SUBJECT: NuScale Power, LLC Response to NRC Request for Additional Information No. 81 (eRAI No. 8877) on the NuScale Design Certification Application

Response to Request for Additional Information Docket No. 52-048

eRAI No.: 8877

NRC Question No.: 19.05 Aircraft Impact Assessment (APR1400)-1

Figure 19.5-1: Reactor Building Equipment Door

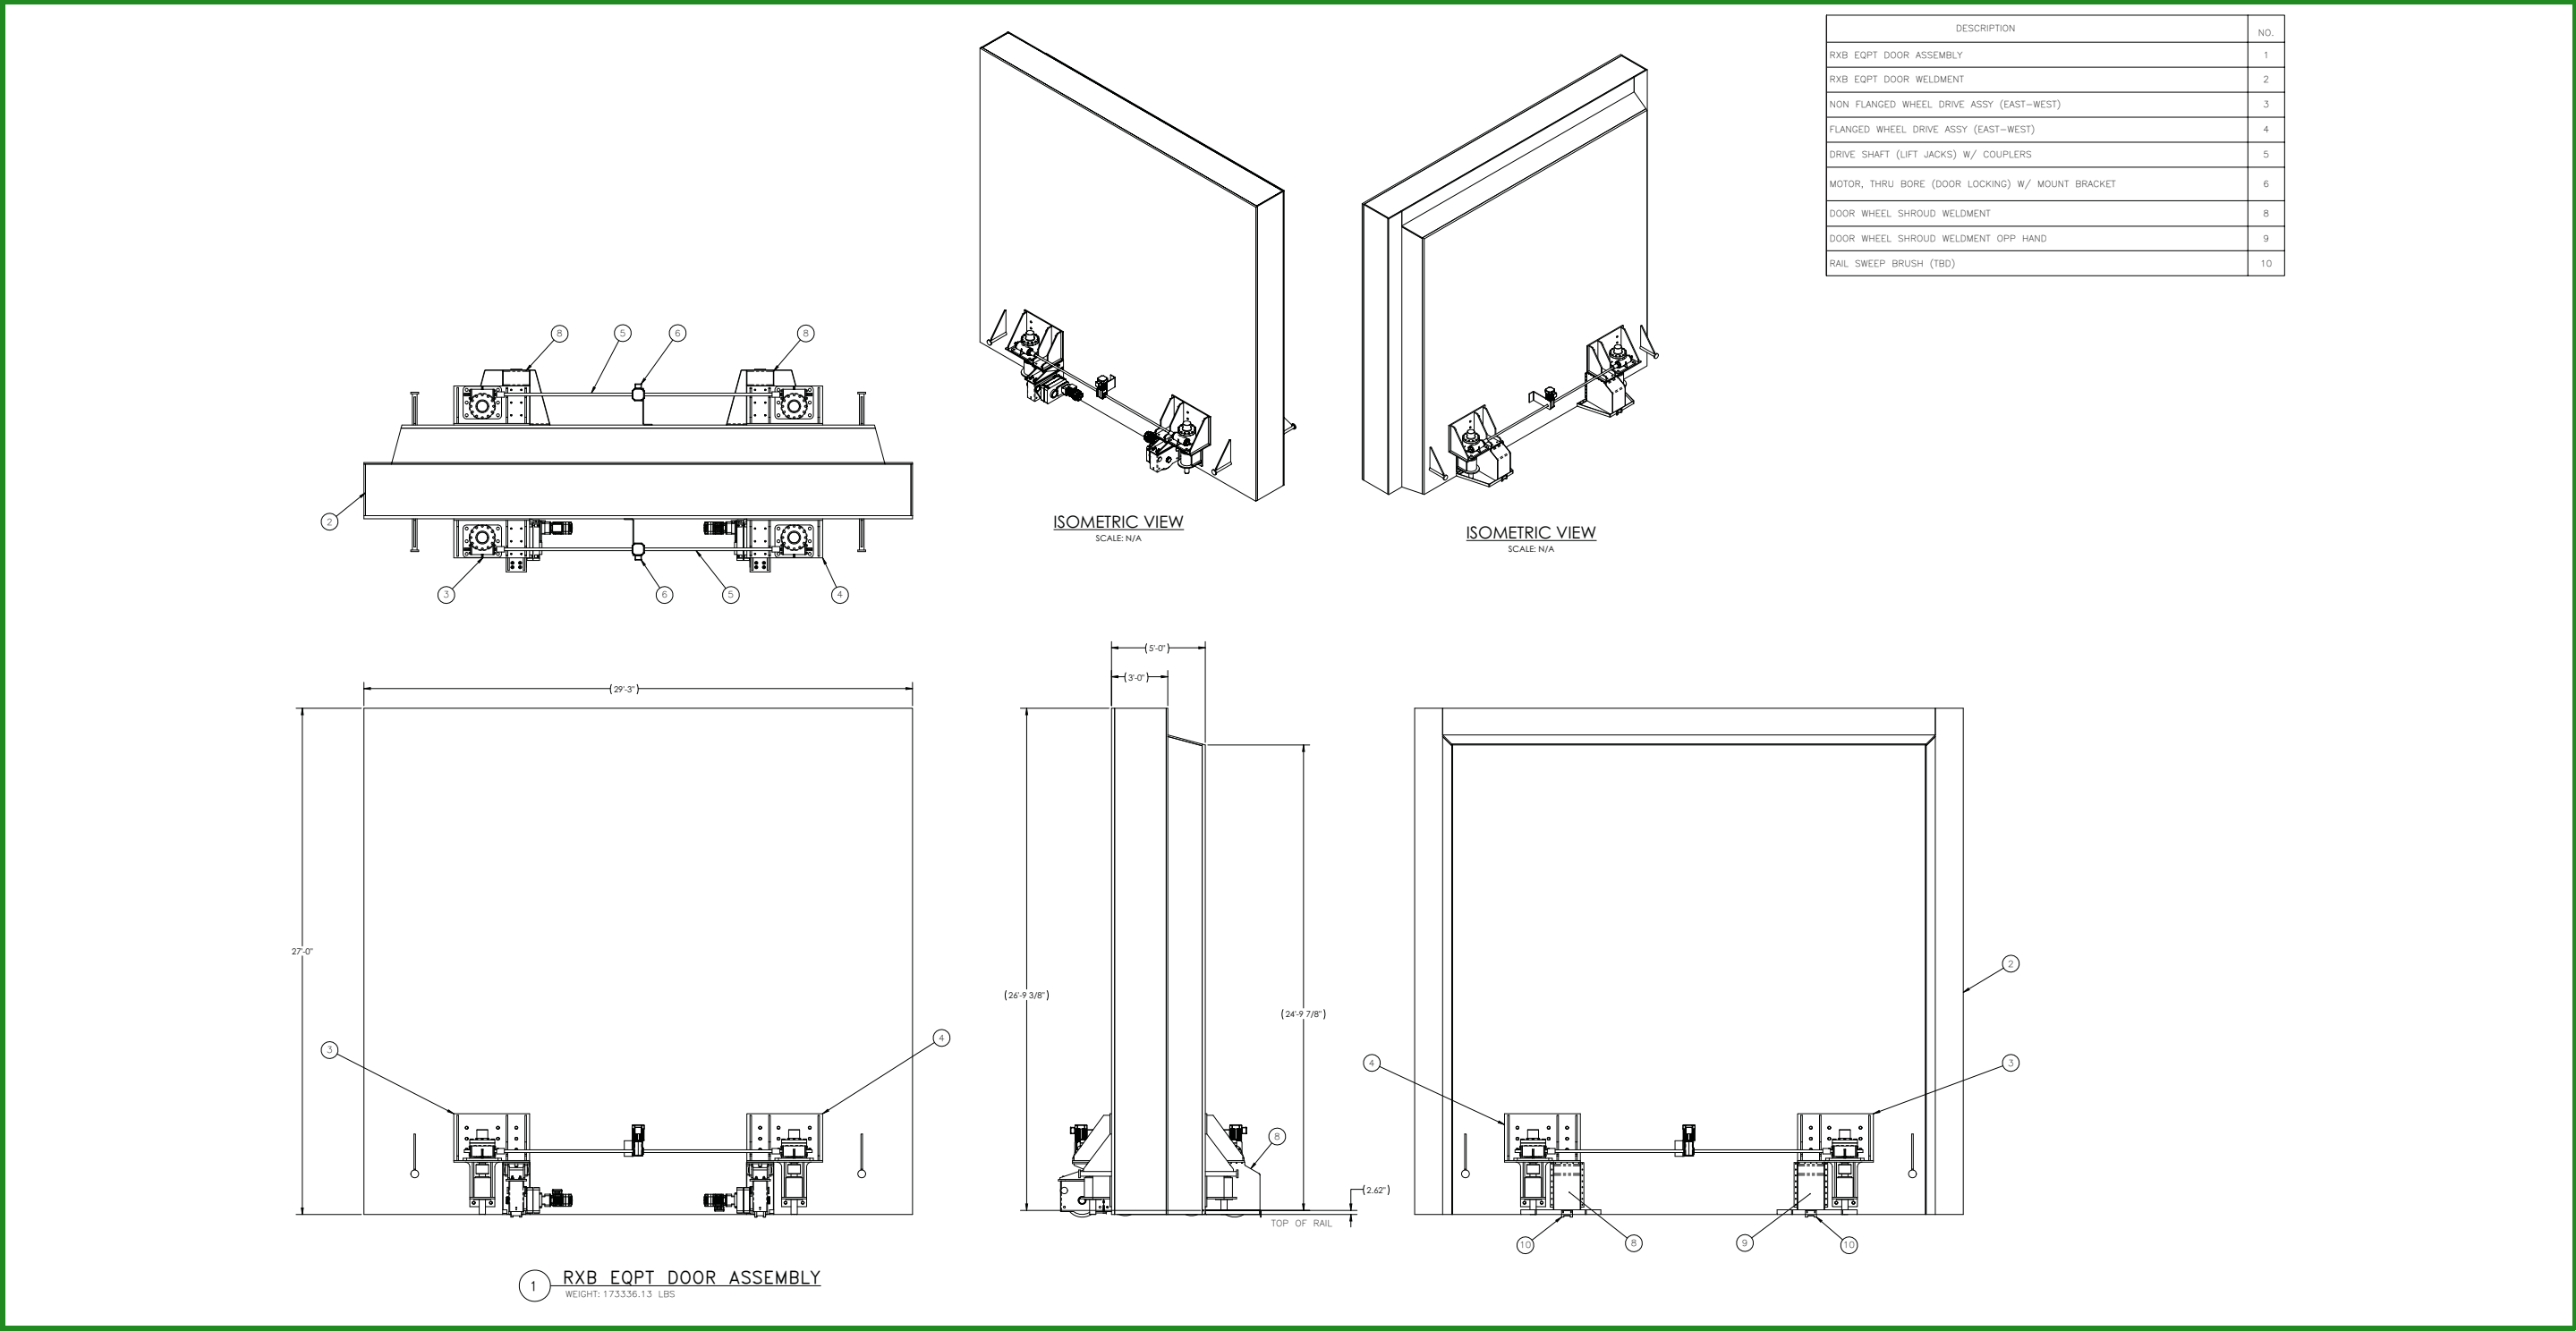
The applicant is requested to clearly identify and describe all the key design features credited in the applicant's AIA as well as these features' role in helping mitigate the consequences of the aircraft impact. Figures and drawings would be helpful to clarify the requested information." The FSAR should be modified accordingly.

The RXB external walls have been assessed and shown to resist physical damage from all postulated aircraft strikes. The design of the RXB as described in Section 3B.2 is a key design feature. The design of the reactor building equipment door to the RXB as described in this section is a key design feature for protecting core cooling equipment from impacts through the RWB Trolley Bay. The reactor building equipment door is a large concrete door that is on a series of rails. It can be moved in place for normal operations, and out of place when large equipment is moved into and out of the reactor building. The door fits like a plug into the exterior wall of the reactor building in that it is tapered along the top and sides and is sealed against the building. The door is five foot thick with steel plate along the outside, and filled with 7000 psi reinforced concrete. The steel plates are either 1" or 2" thick, and the reinforced concrete consists of three layers of #11 bars at 12 inches on center on each face of the door, and #6 set ties that are staggered (see Figure 19.5-1 through Figure 19.5-3).
